TXDOT AVIATION STATEWIDE AIRPORT ELECTRICAL CONSTRUCTION PROJECT (AVSAE) - GROUP ALPHA
TxDOT CSJ No. 4222AVSAEA

ADDENDUM NO. 3

May 14, 2025

1 ES4.1 **VAULT EQUIPMENT DEMOLITION PLAN**

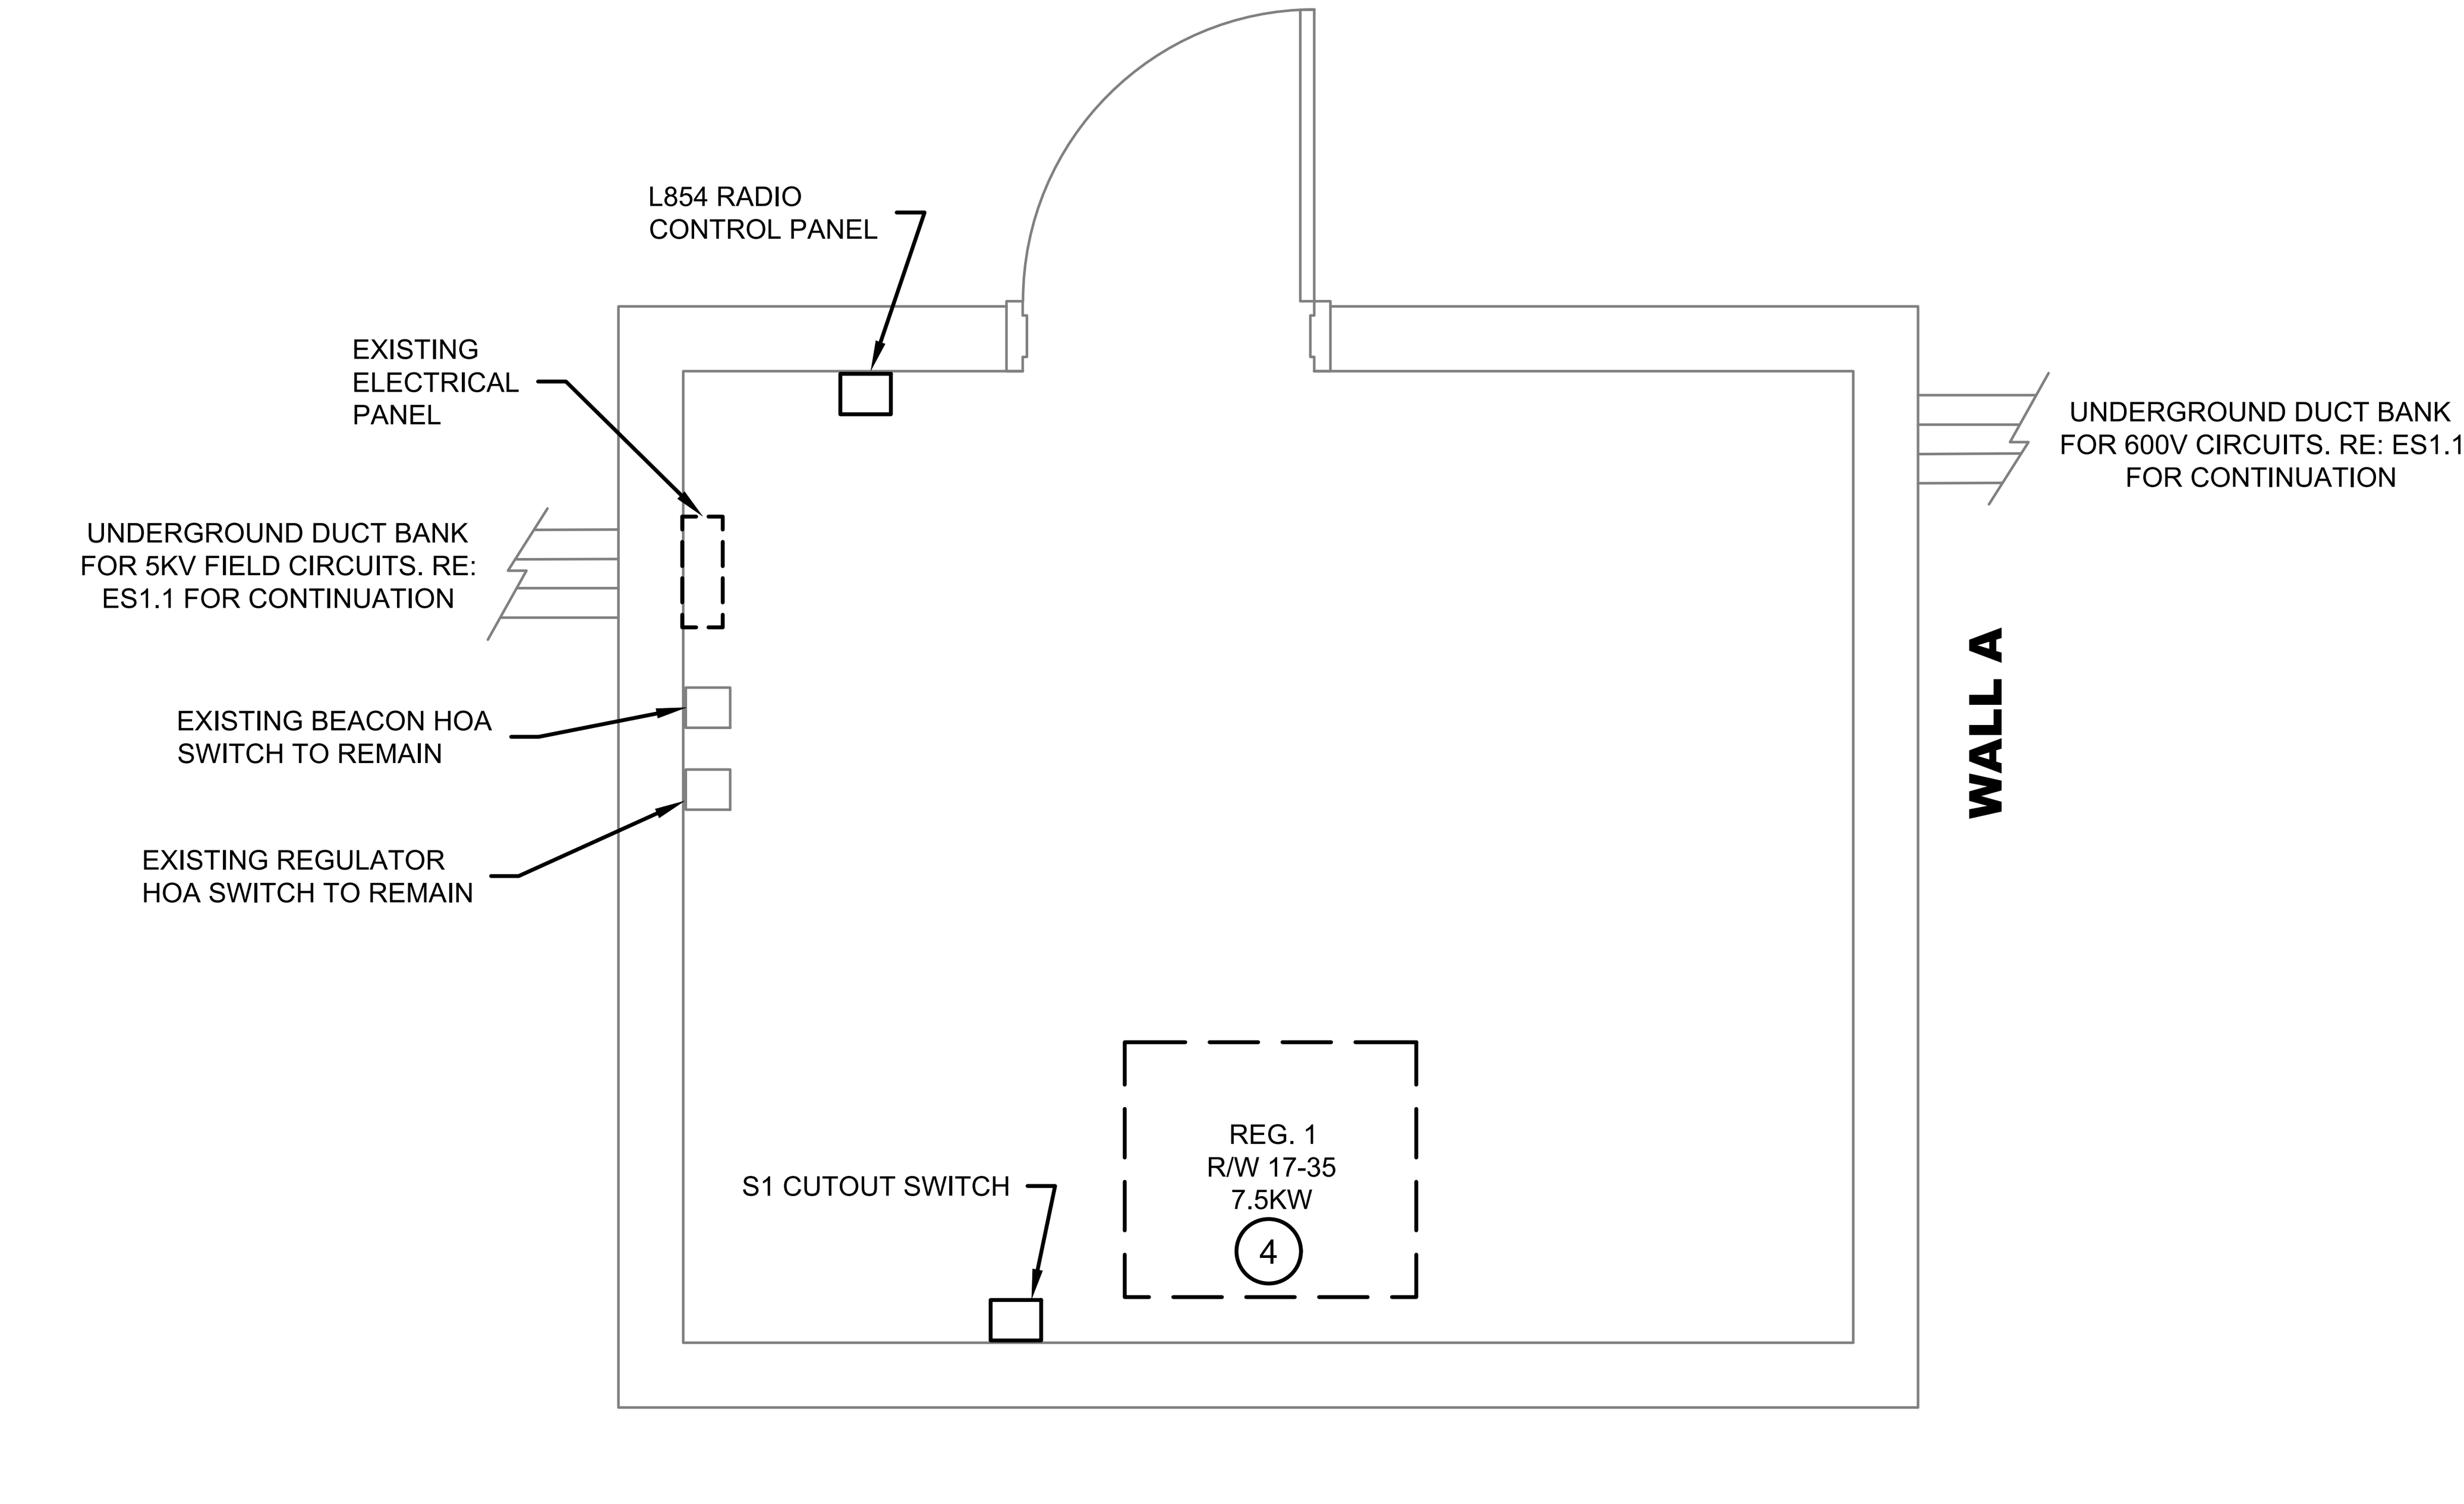
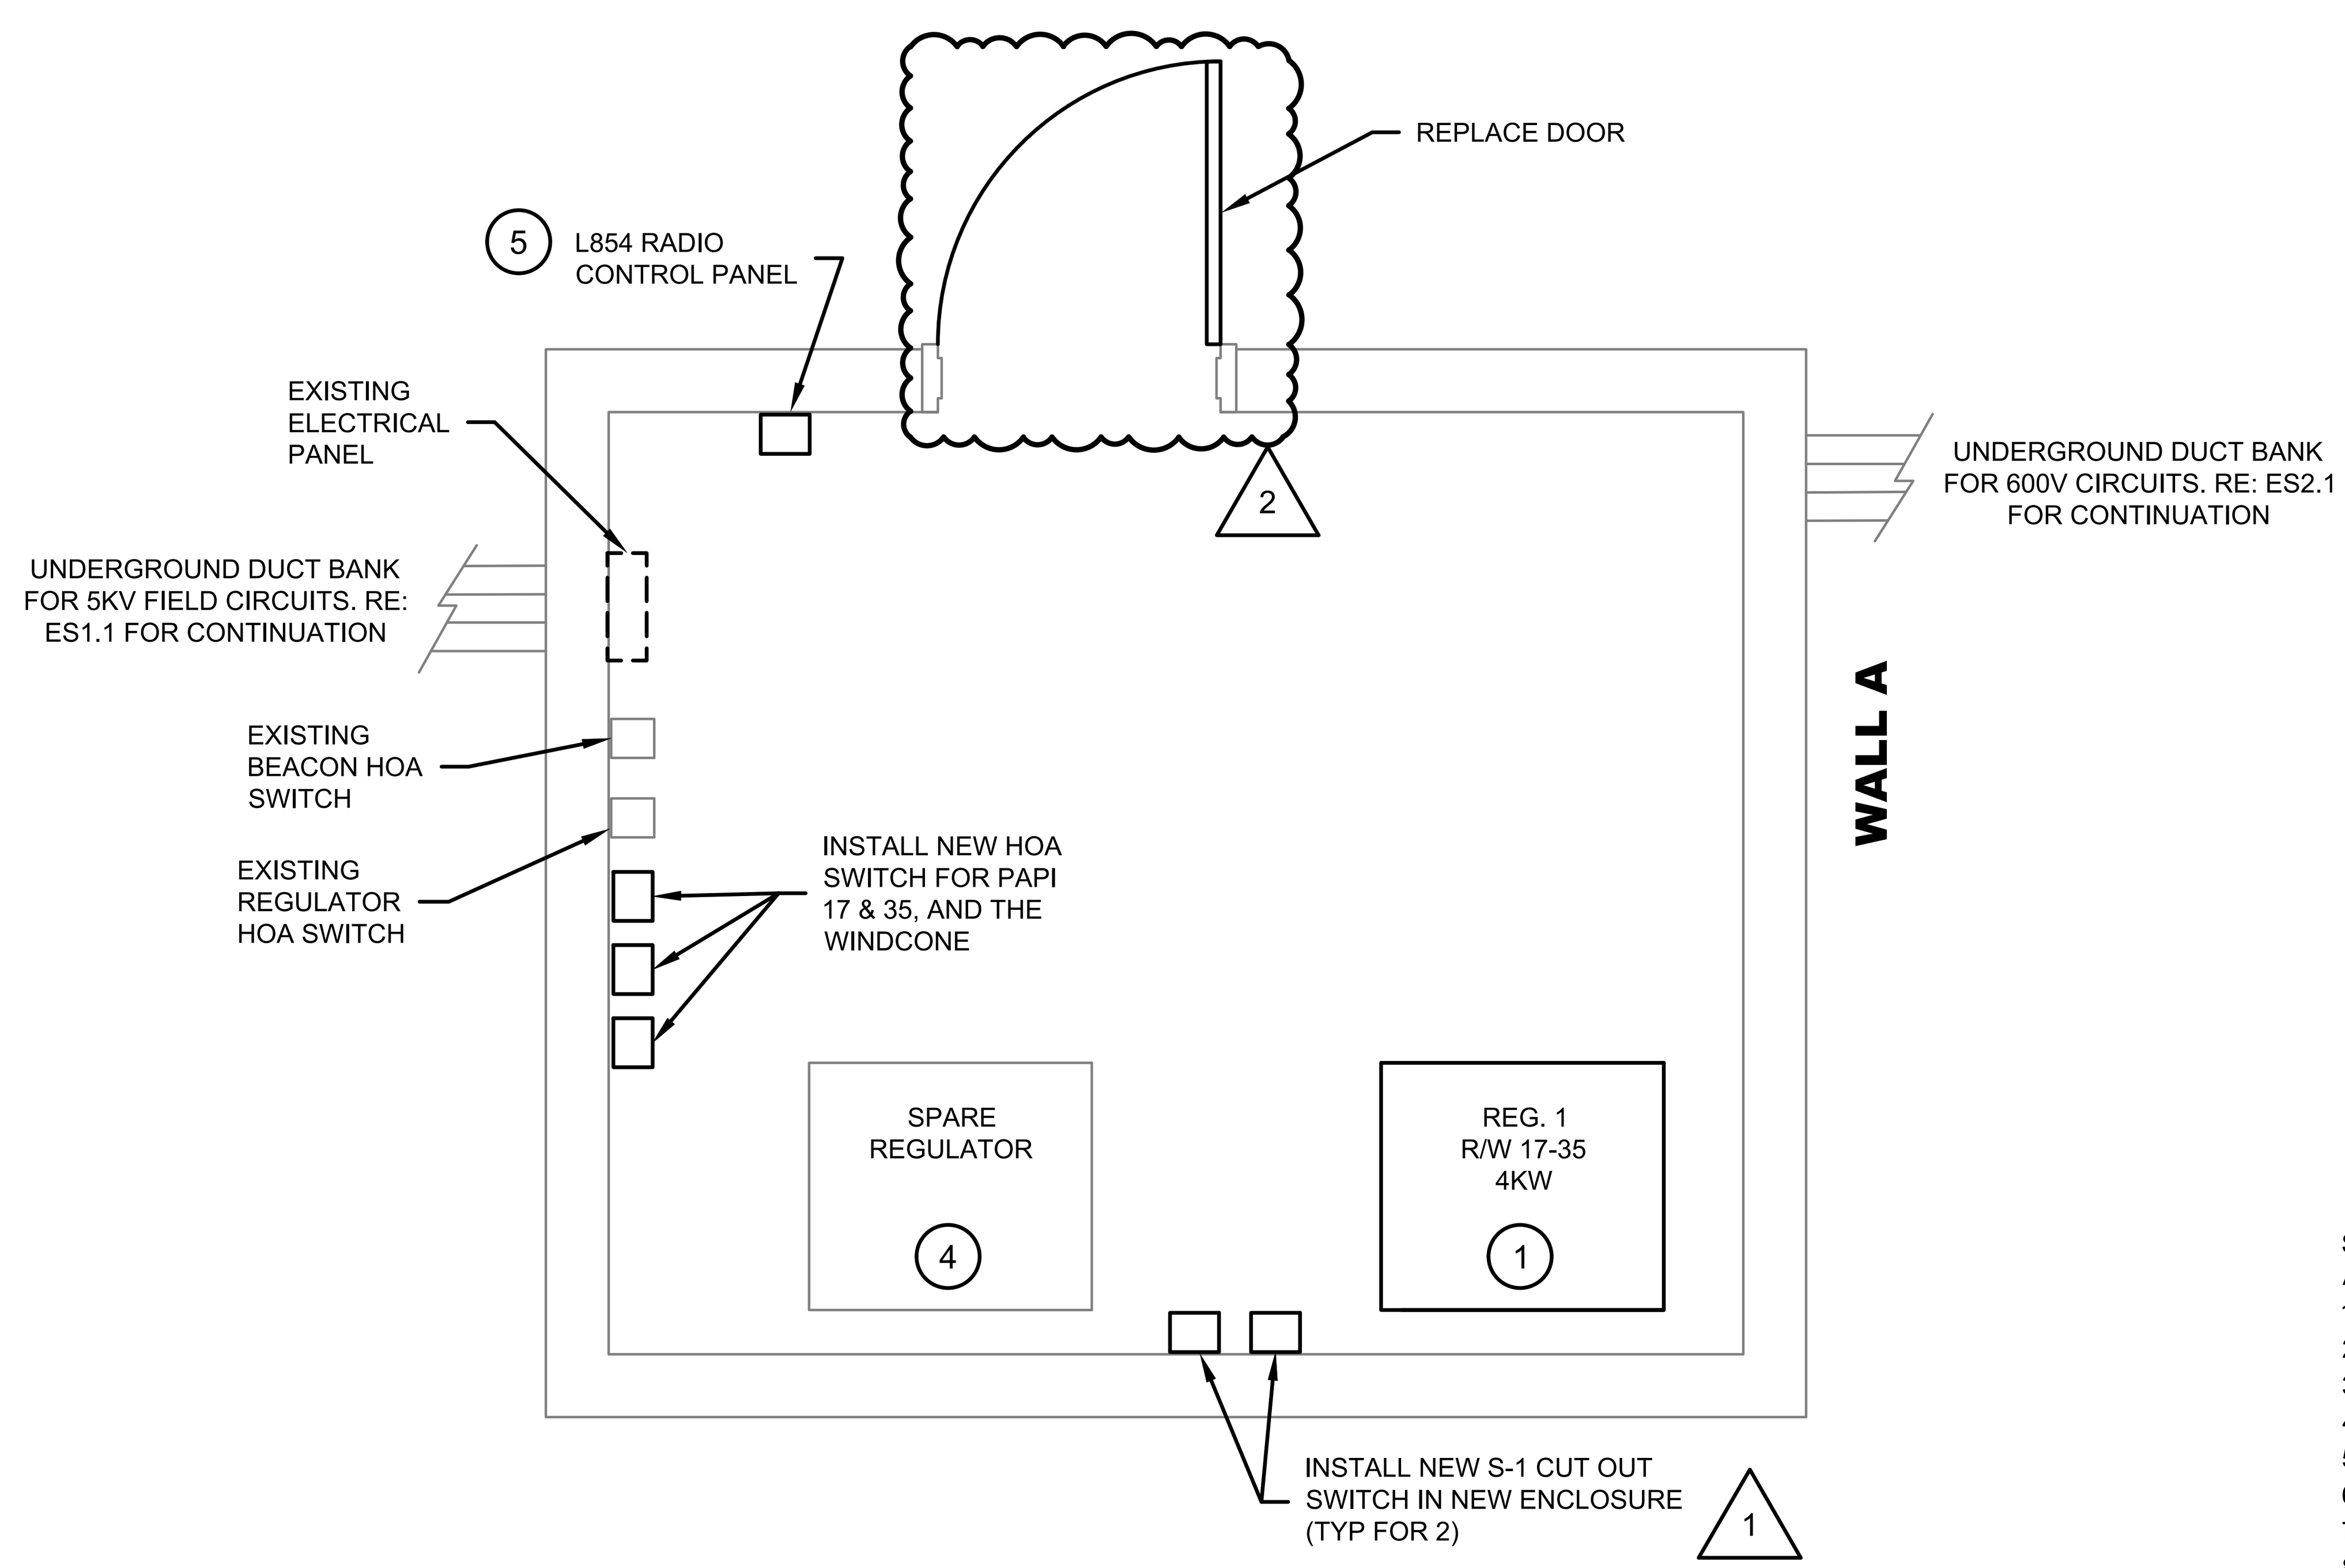
mmm) Sheet ES4.1 –Electrical Vault Plan. Revised details to clarify door replacement scope. Updated panel schedule.
